RE: Terex Telelect Inc. Aerial Devices and Digger Derricks

## DEFECT INFORMATION REPORT

**CAMPAIGN BULLETIN**

**SUBJECT:** Miller "D" lanyard anchor p/n 472452

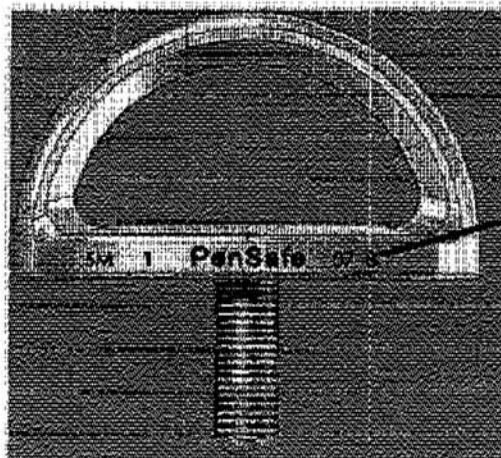
TEREX Utilities has received notice of a recall from the supplier of the D shaped lanyard anchor, p/n 472452 with the date code 07B. There is a deficiency in the material strength that may cause the threads on the stem to fracture prematurely. These parts could be on machines built from June, 2008 through November, 2010.

**During a fall arrest event the D shaped lanyard anchor can fail.**

Immediately inspect the lanyard anchors on units listed in the attached letter for lanyard anchors having the date code 07B, as shown below. Immediately take the unit out of service if the date code appears. If the date code does not appear, simply complete the enclosed form to complete this bulletin.

If your lanyard anchor is affected, call TEREX Utilities, at 605-884-3892 for a replacement kit, p/n Z-1200. Follow the installation instructions that accompany the kit. Complete the enclosed form and return it with the affected anchor to TEREX Utilities, using the shipping label and shipping box, for credit.
